ADDENDUM NO. 2

August 4, 2022

**Silver Creek High School Additions & Renovations
557 Renz Avenue
Sellersburg, IN 47172**

This Addendum forms a part of and modifies the Bidding Requirements, Contract Forms, Contract Conditions, the Specifications and the Drawings dated July 8, 2022, by CSO Architects.

DRAWING NUMBER
C403

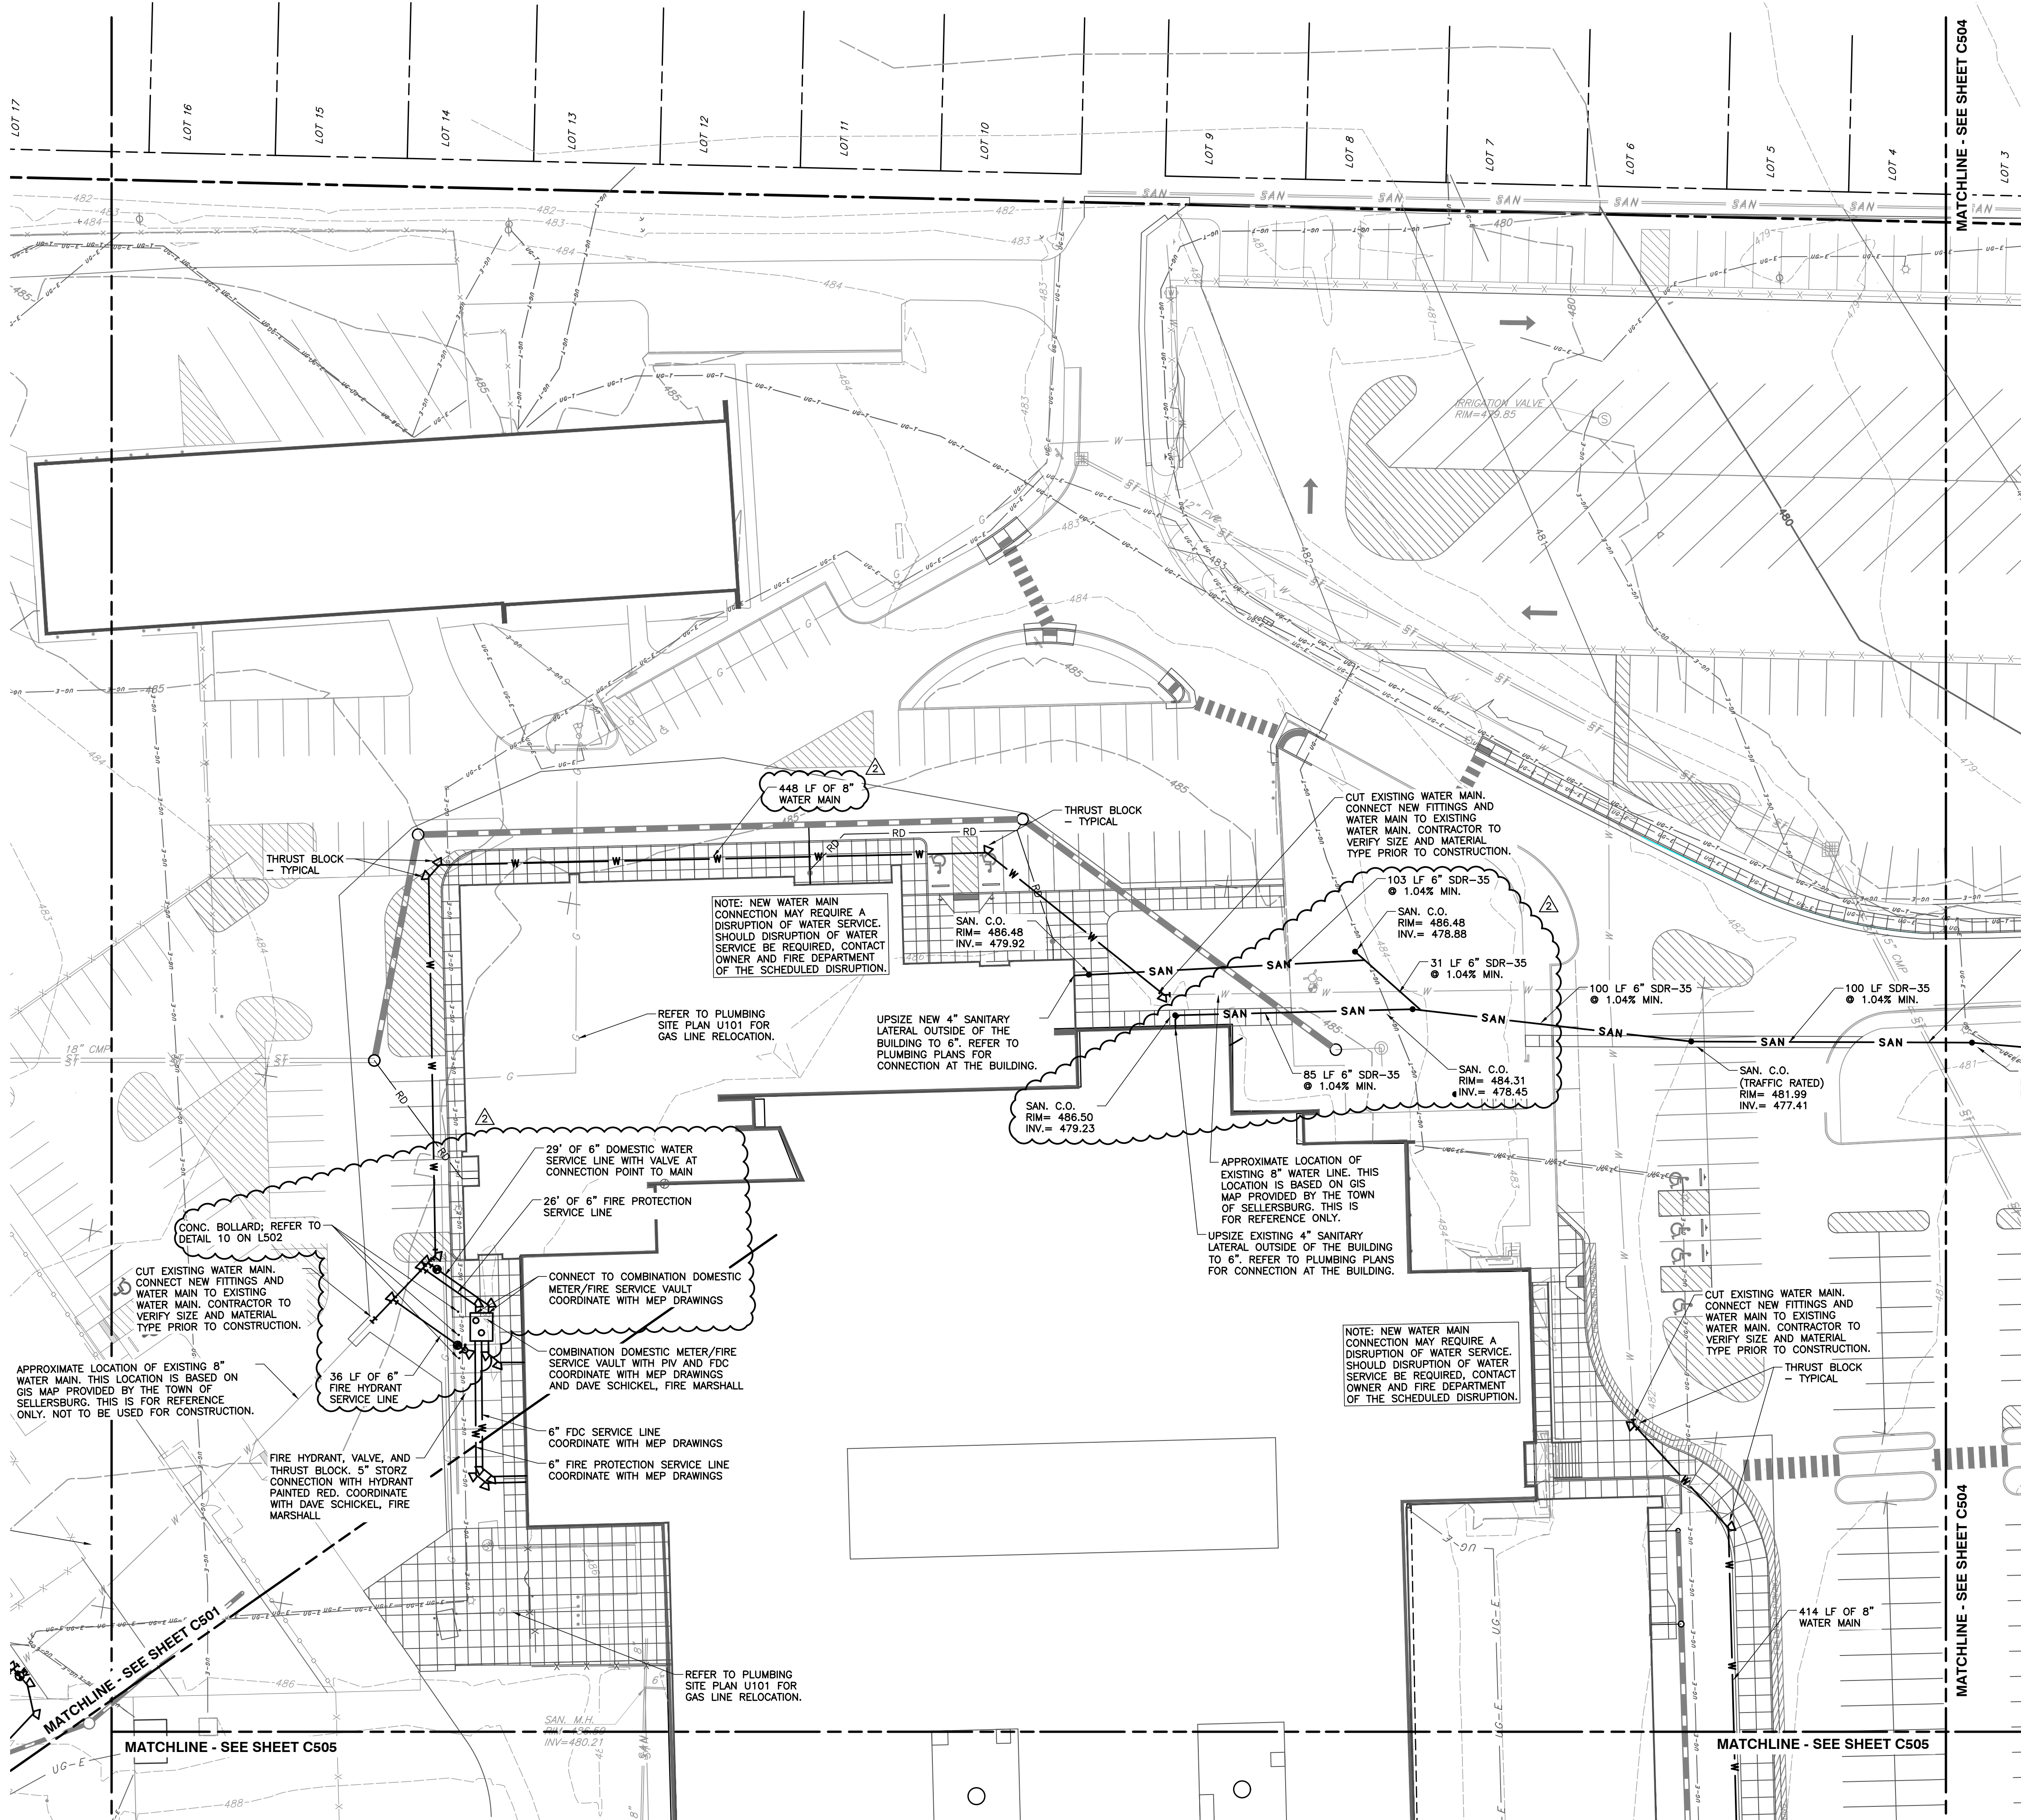
3.6 C403 – DRAINAGE PLAN

- A. Revised roof drain size from 8" to 12" to match Plumbing Plans for Auditorium addition.
